Year 7 Monitoring Report

UT Millers Creek
Duplin County, NC

DMS Project ID No. 95719 Contract No. 5000

Subject: DMS Comments
UT to Millers Creek, Project ID #95719, DMS Contract #5000

Current Condition Plan View - Year 7
 UT Millers Creek, Duplin County, North Carolina

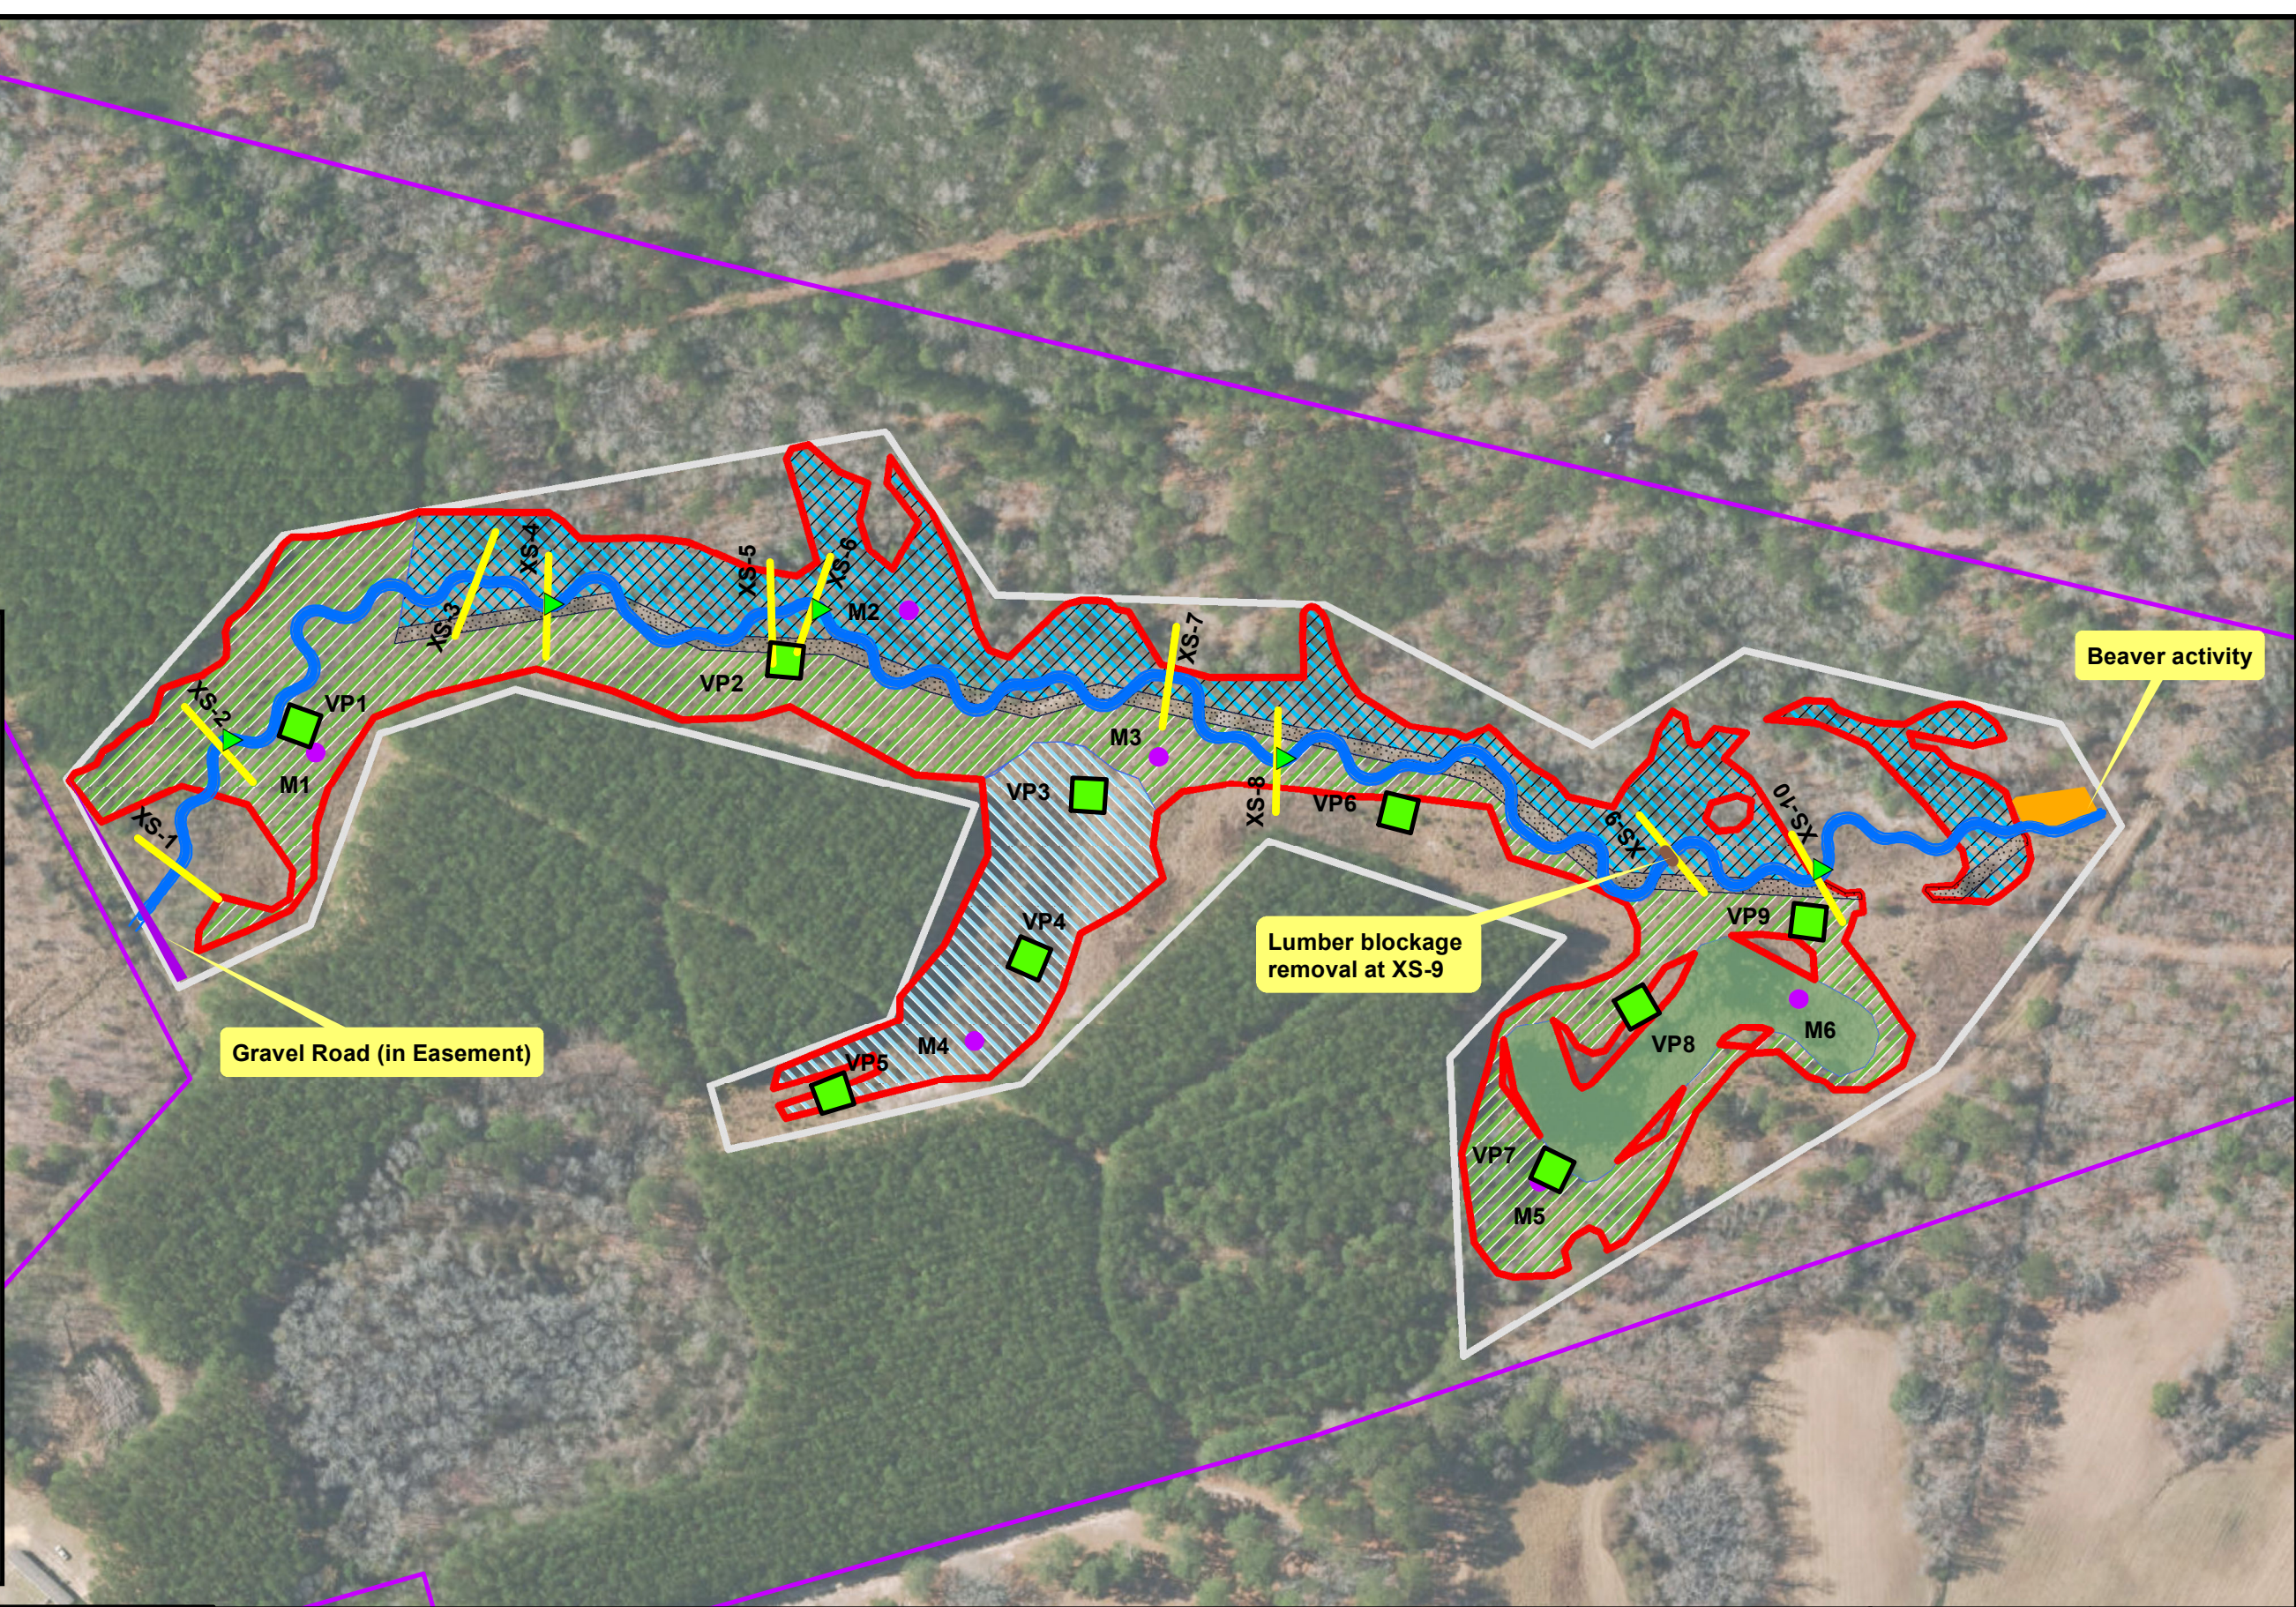
2. DMS: Revise shapefile on CCPV to show label as “gravel road” rather than “vegetation encroachment.”
HDR: “Gravel Road (in Easement)” is depicted on the legend and as a call out CCPV.
3. DMS: Provide picture of gravel road for report.
HDR: The gravel road is depicted on page 19 as Figure 3.10.
4. DMS: Provide vegetation plot height data (table) for IRT consideration.
HDR: Vegetation plot height data has been added as Table 8. Planted Tree/Shrub Height Data.

HDR: The paragraph amended to: During the stewardship site visit in October 2021 by DMS staff, it was discovered that a small portion of the gravel road was installed during project construction, impacting the southeastern property corner. This went unnoticed during monitoring. DMS property staff added this road to the infrastructure layer to ensure it does not expand or migrate as the project moves into the stewardship phase. The southeastern easement boundary (witness post #14) was removed from its original location. Table 6 notes the acreage of the encroachment and Figure 2.1 illustrates the area.

Figure 4.1, XS-1 Riffle

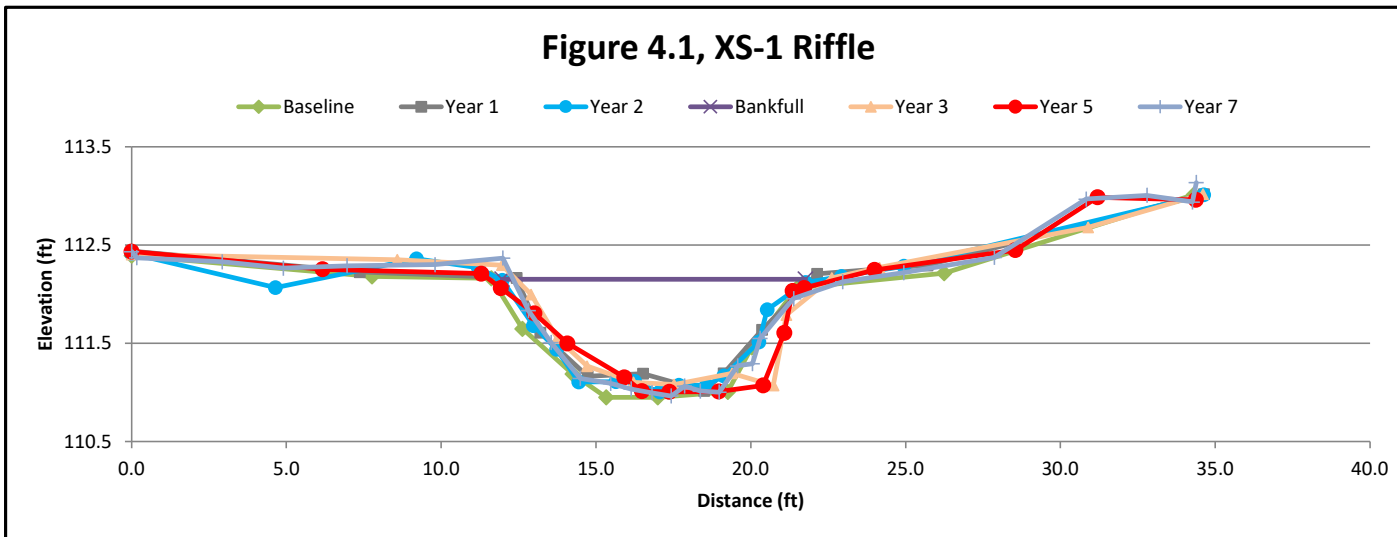
2. DMS: Certain BHR values do not appear to correspond with calculated BHR values. For example, the current BHRs for XS-1 and XS-7 should be 0.8 and 0.9, respectively. Note that to validate reported BHR's the current low bank height was used to determine the low bank height elevation since a low bank height elevation wasn't explicitly identified.

HDR: *BHR values as well as other Y7 cross section values have been updated per our discussions following review. These affected the riffle cross section plots as well as tables 10 and 11. Figures and tables have been revised.*

Gauge #6 (14E142FD)

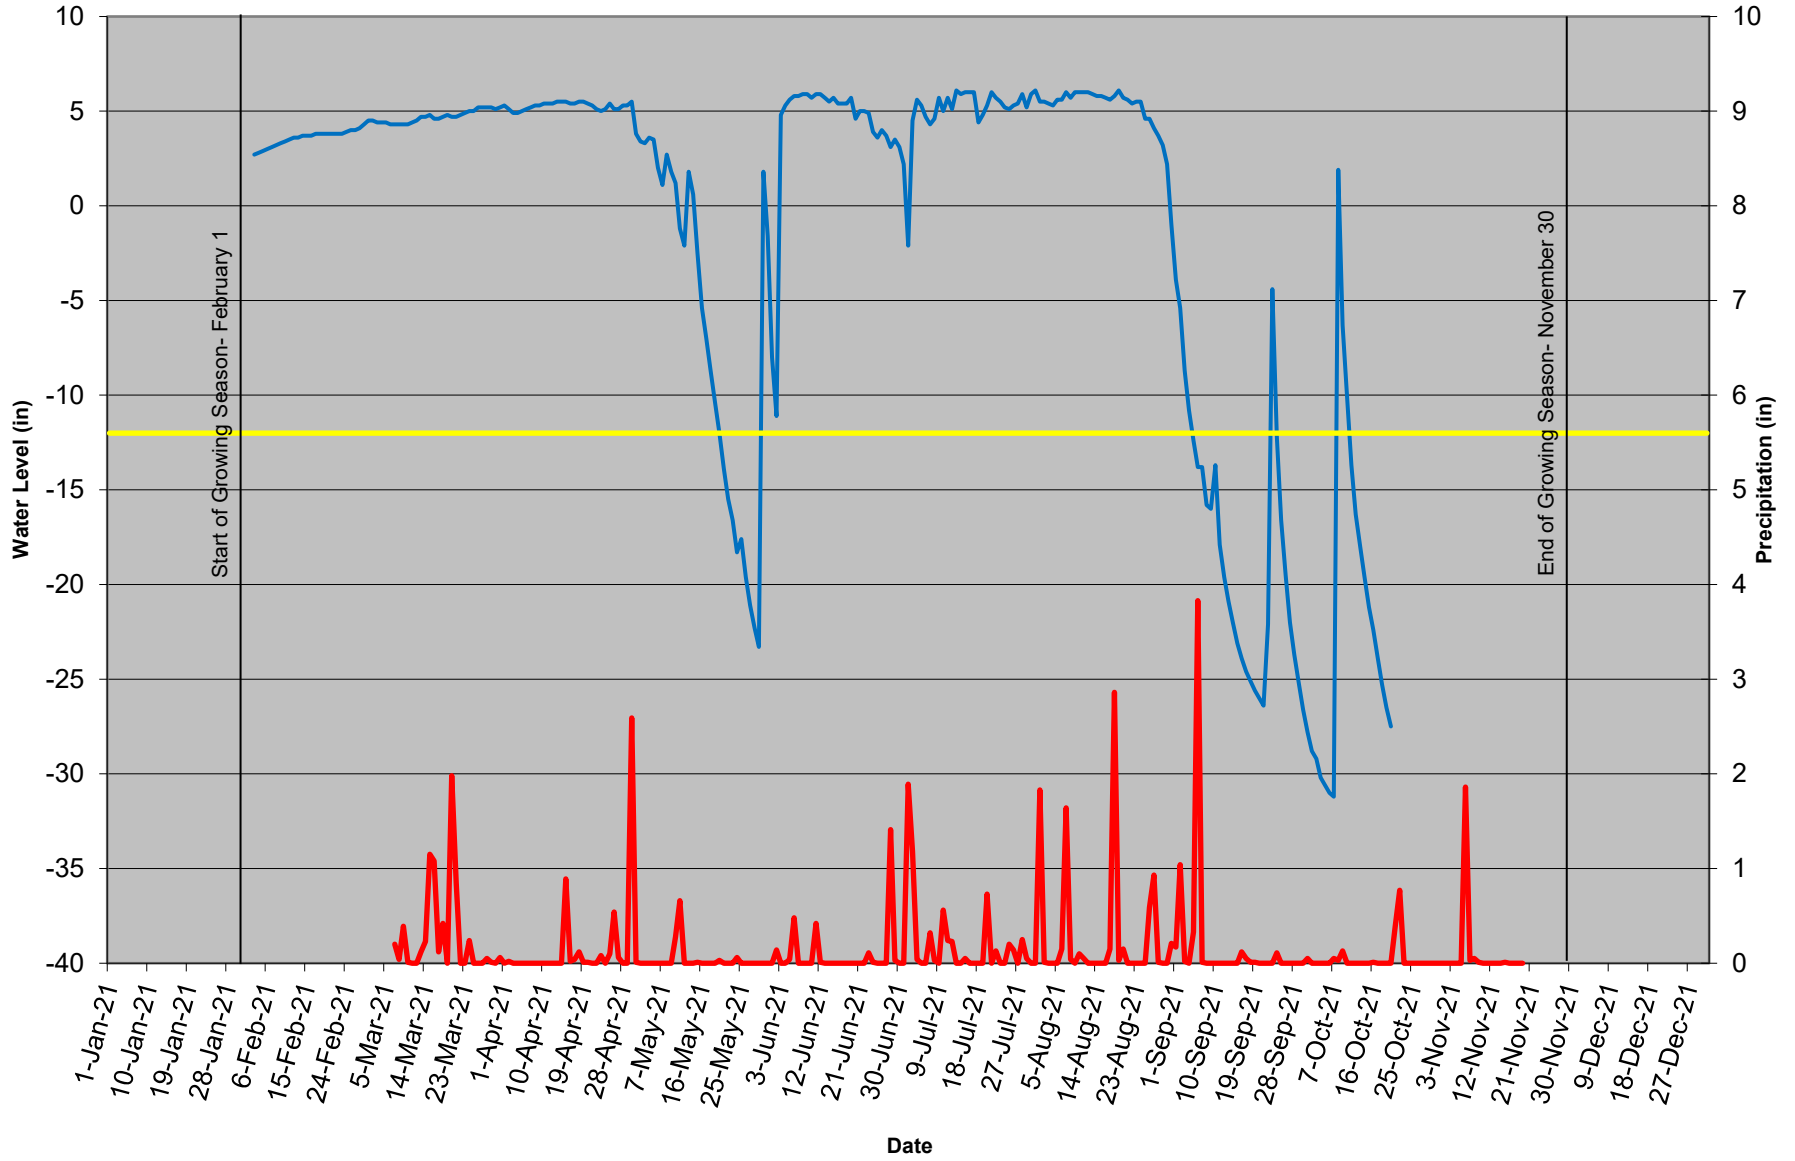
3. DMS: Please review reported values in Table 12. As an example, it does not appear that there were 222 consecutive days where the water level was above -12 in. for gauge 6.

HDR: *For gauges 1, 5 & 6, consecutive days where the water level was above -12 inches were changed/corrected in Table 12 (now Table 13).*
